CLEVE HILL SOLAR PARK

RESPONSES TO THE EXA'S WRITTEN QUESTIONS - APPENDICES
Appendix 13 – Letters Between Cleve Hill Solar Park Ltd And The
Environment Agency Dated 13 April 2018 And 8 May 2018

Cleve Hill Solar Park – Flood Defence Management

Cleve Hill Solar Park (CHSP) – Flood Defence Management

Site Boundary Comparison

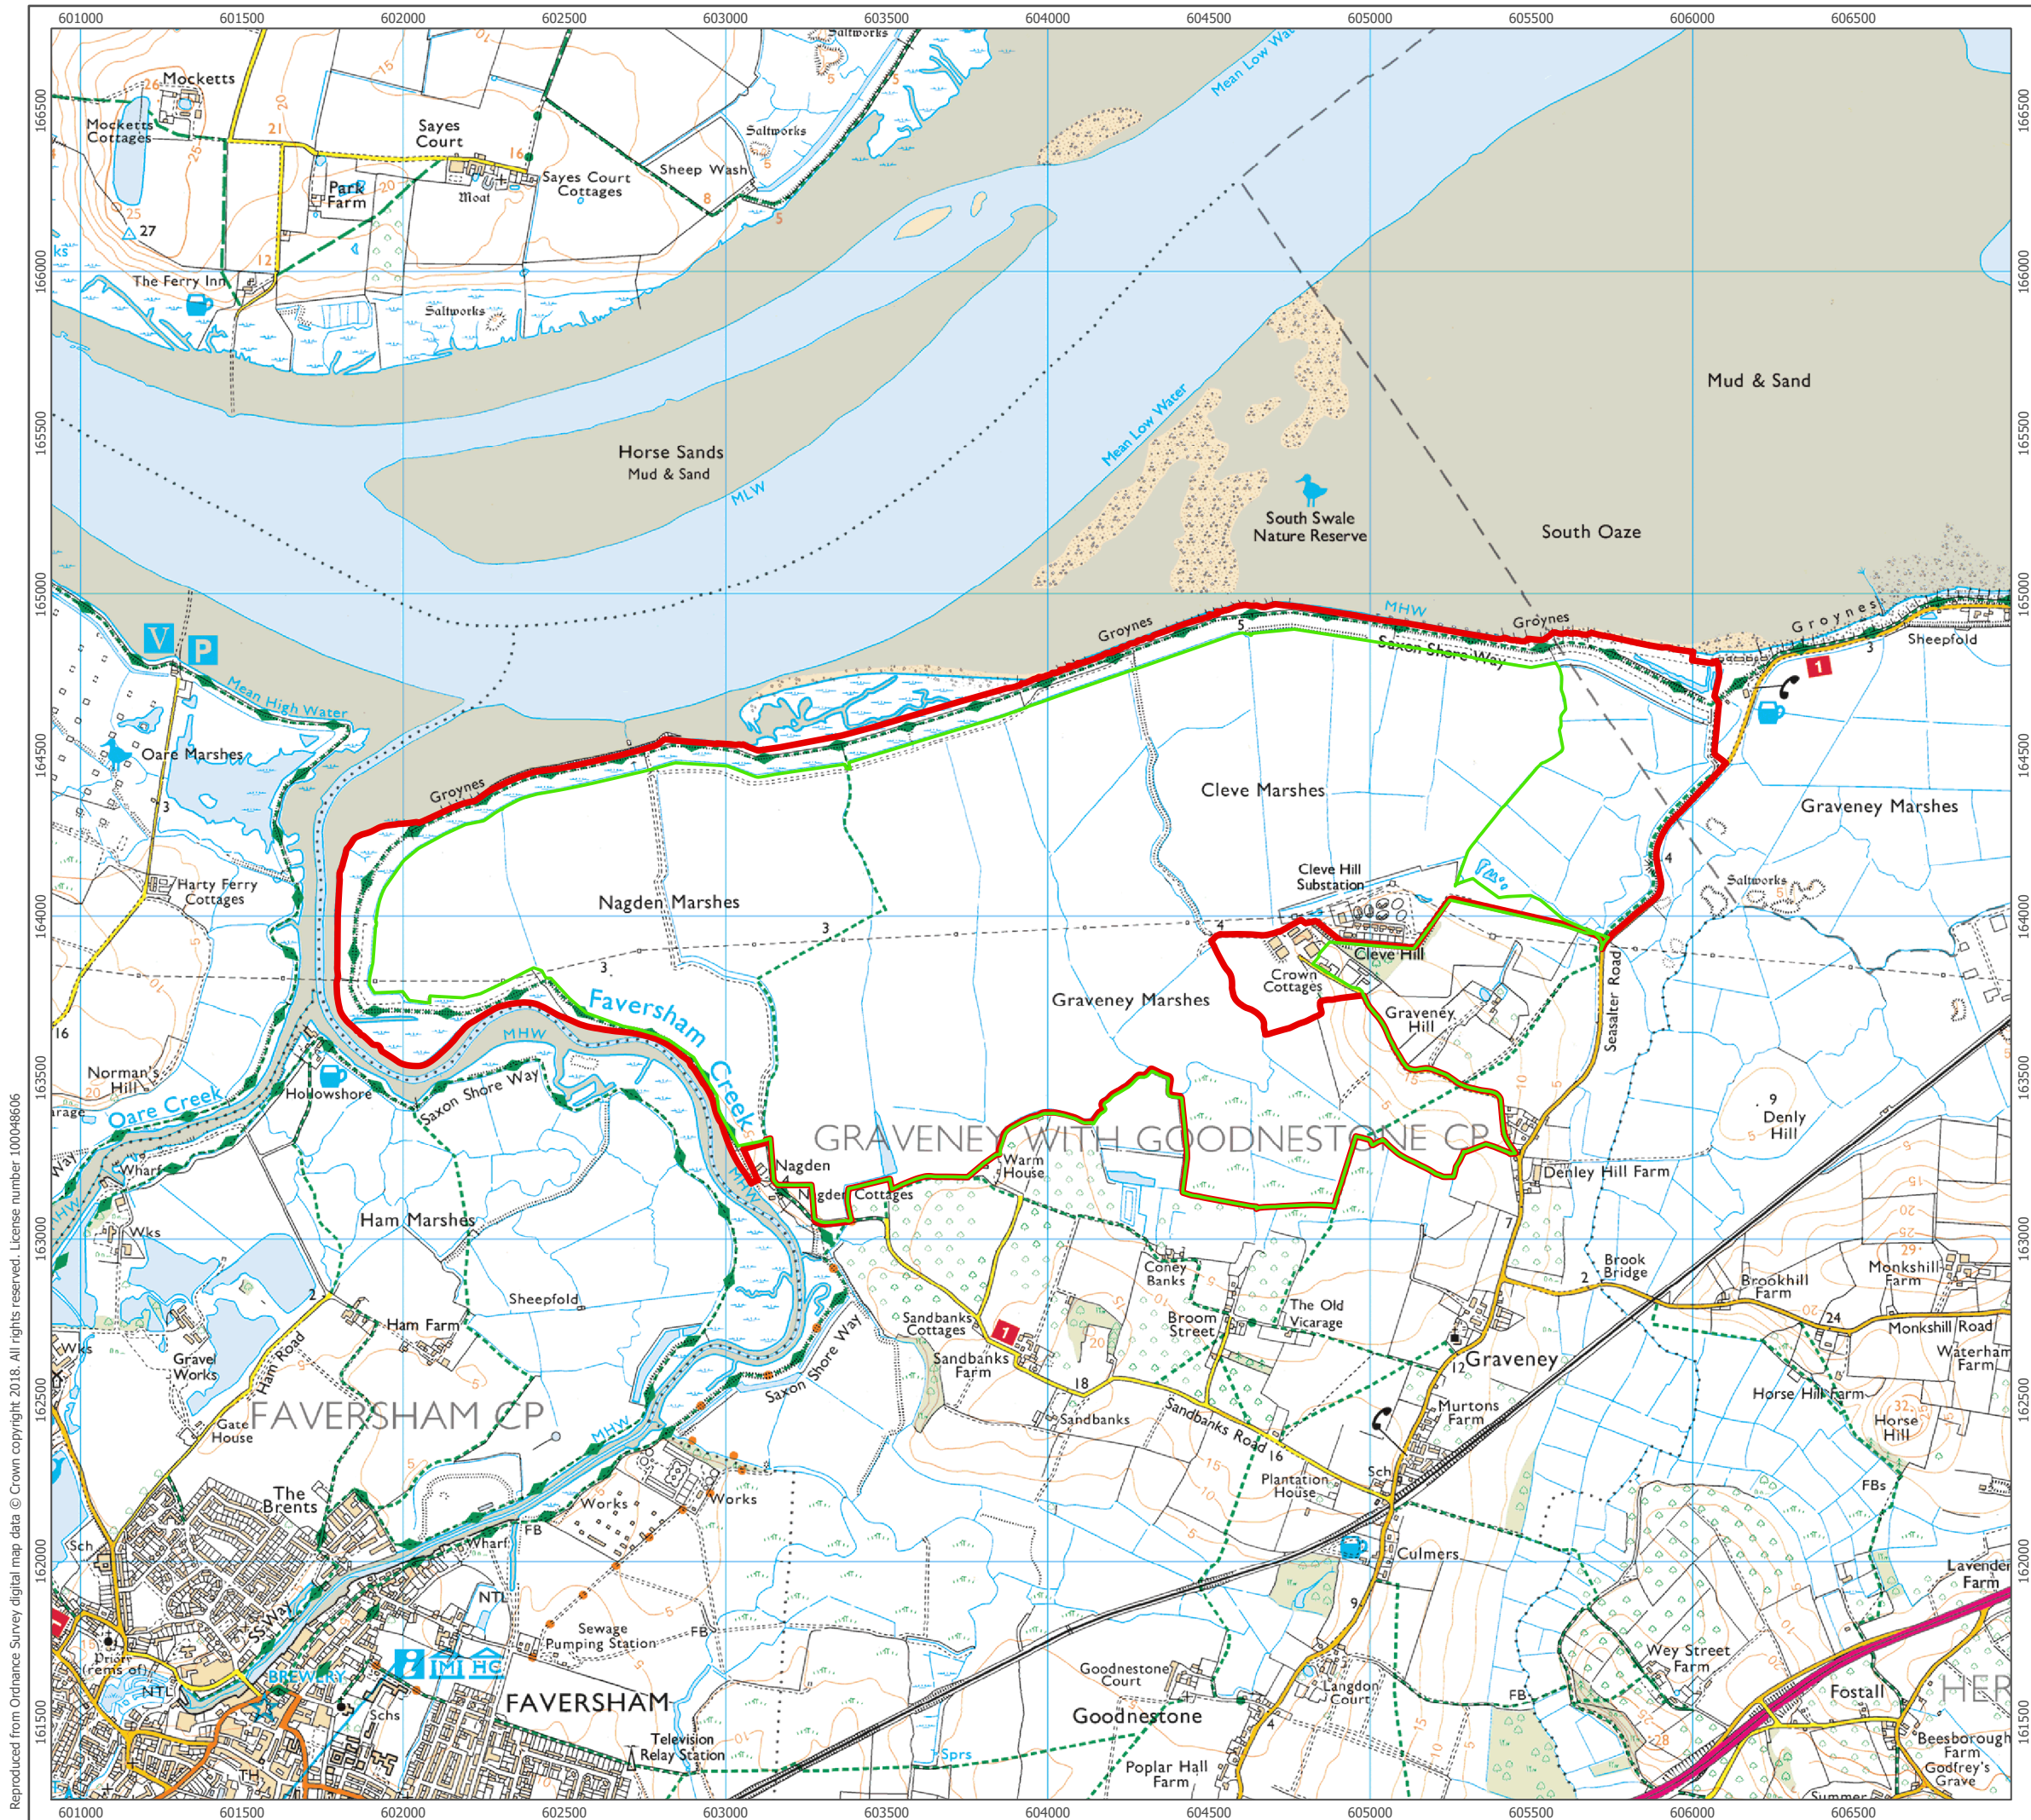
I have enclosed a plan of the site showing the currently expected DCO Application boundary revision. There is work ongoing which will contribute to the finalisation of this boundary revision.

At Nagden, there is a discrepancy between the flood defences shown on the flood map which protect the site, and the flood defences marked on the MEASS BA6.2 plans. We have relied upon the flood map as the definitive version of the flood defence alignment rather than the defences marked in the MEASS plans. Please confirm that you agree this is the correct approach.

The flood defences at the site and wider area are not fully shown on the published flood map. The defence line is continuous from Cleve Hill to Nagden and to the south west beyond. MEASS Benefit Area 7.2b - which adjoins Cleve Hill to the south west – is a Hold the Line (maintain) frontage.

We discussed your proposal to extend the CHSP red line boundary to include the flood defences protecting the site, and the inclusion of powers and rights in your DCO to enable CHSPL to undertake maintenance works to the defences. We would not have any concerns or objections with this approach in order to give CHSPL the ability to maintain the defences in the future. The defences beyond the CHSP site boundary would be maintained by the Environment Agency within MEASS Benefit Area 7.2b (subject to partnership funding being available).
